DOCKET ITEM #16

**Hoffman Block 2 - TSA**  
**Stage I Development Special Use Permit 2014-0027**  
**Master Plan Amendment 2014-0009**  
**CDD Concept Plan CDD Amendment 2014-0004**

<b>Purpose of Application</b>
<p>Approval of a request to transfer approximately 310,000 square feet of floor area from Hoffman Blocks 4 and 9, to Hoffman Block 2, and to allow for an increase in building height from 210 feet to 260 feet. The application also includes approval of request to transfer 70 parking spaces from Block 4 to Block 2. The request includes the following applications:</p> <ol style="list-style-type: none"> <li>1. Stage I Development Special Use Permit with Site Plan;</li> <li>2. Master Plan Amendment;</li> <li>3. CDD Plan Amendment;</li> </ol> <p>* Expiration date per Condition 5 of CDD  ** Allowable Gross Floor Area (AGFA)</p>

<b>Staff Recommendation: APPROVAL WITH CONDITIONS</b>
<b>Staff Reviewers:</b> Gary Wagner, RLA <a href="mailto:gary.wagner@alexandriava.gov">gary.wagner@alexandriava.gov</a> Trey Akers, LEED AP <a href="mailto:trey.akers@alexandriava.gov">trey.akers@alexandriava.gov</a>

Figure 3.  
(Plan View of Alternate Access from Stovall Street)

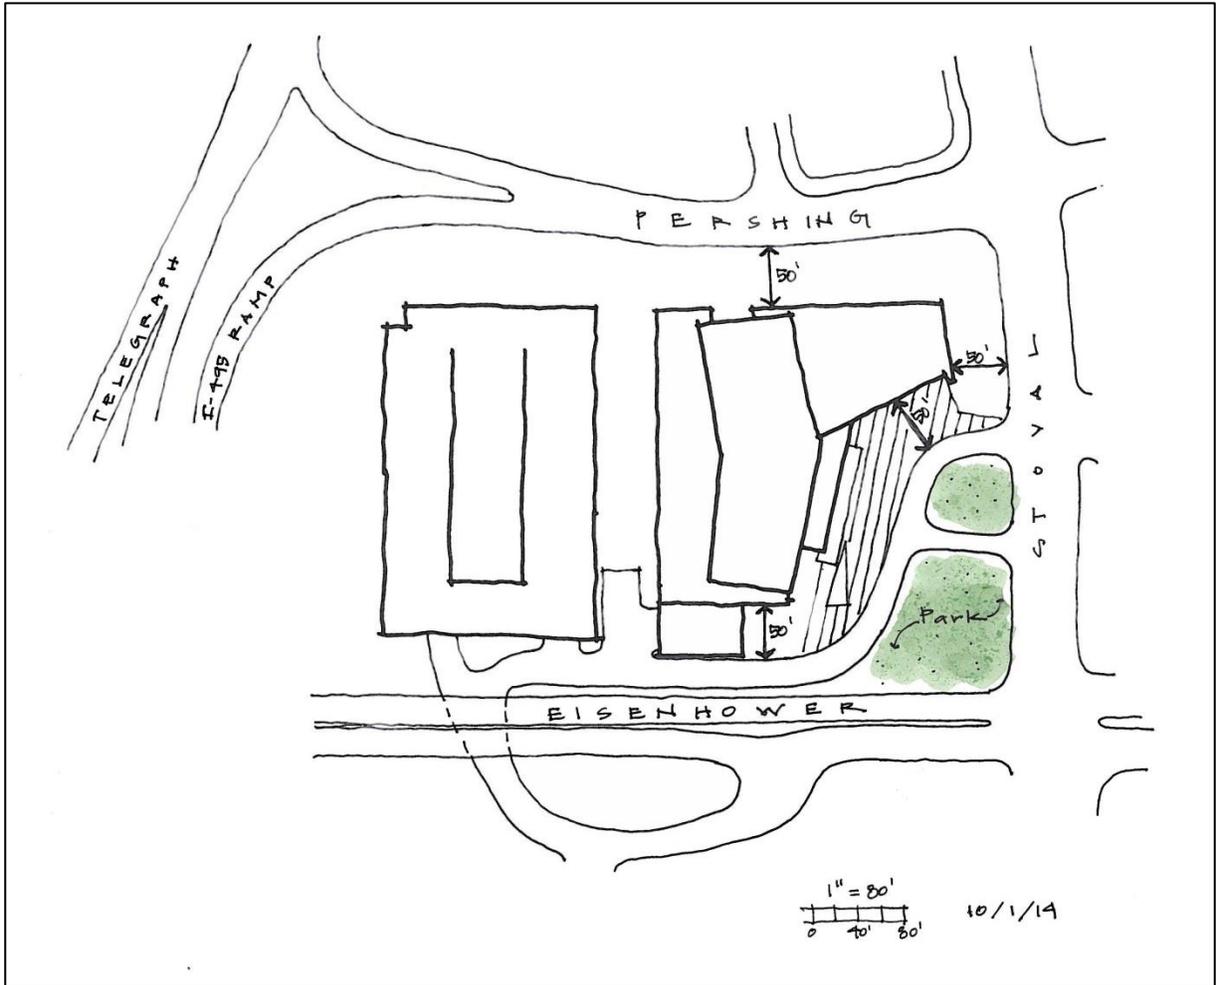
- Staff and the Board raised concerns about vehicular site access as shown, and suggested flipping the office tower footprint, to potentially eliminate the garage access from Pershing Street and open the site plan up to the corner of Eisenhower and Stovall. There would then be a direct entrance and exit to the lobby/dropoff area from Stovall, which could connect with the south garage access off of Taylor Drive. Staff explored this concept in sketch form (see Fig's. 2 and 3), and the Board generally felt it to be a much more positive relationship to the urban fabric. Since the park space (WestSide Garden), would then become more of a forecourt to the new building, and it was thought that the balance of the public open space could be recaptured on Block 3.

Tower 203 Turning Specifications

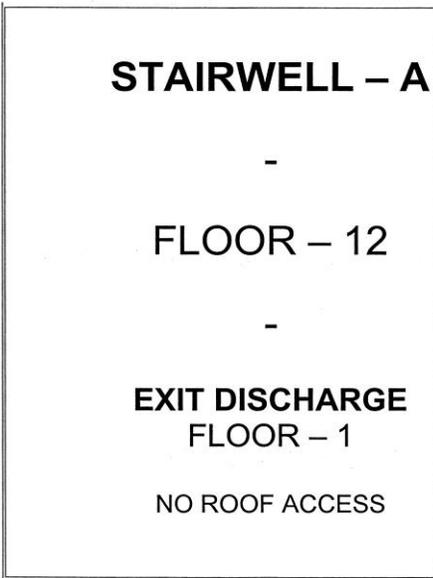
161. Show fire apparatus vehicle turning radius based on the following specifications:

- Turning Radius – Wall to Wall = 54.98 feet + / - 2 feet  
Curb to Curb = 51.33 feet + / - 2 feet  
Inside turning radius = 37.73 feet + / - 2 feet
- Overall Length – 47' – 4 1/2"
- Overall Width – 98"
- Wheel Bases from front axle to both rear axles – 240"
- Tandem axle spacing – 56" CL of axle to CL of axle
- Gross Weight – As built with no equipment or water gross weight = 66,000#
- Angle of Approach – 13 Degrees
- Angle of Departure – 11 degrees
- Ramp Break Over – Break over angle is 9°
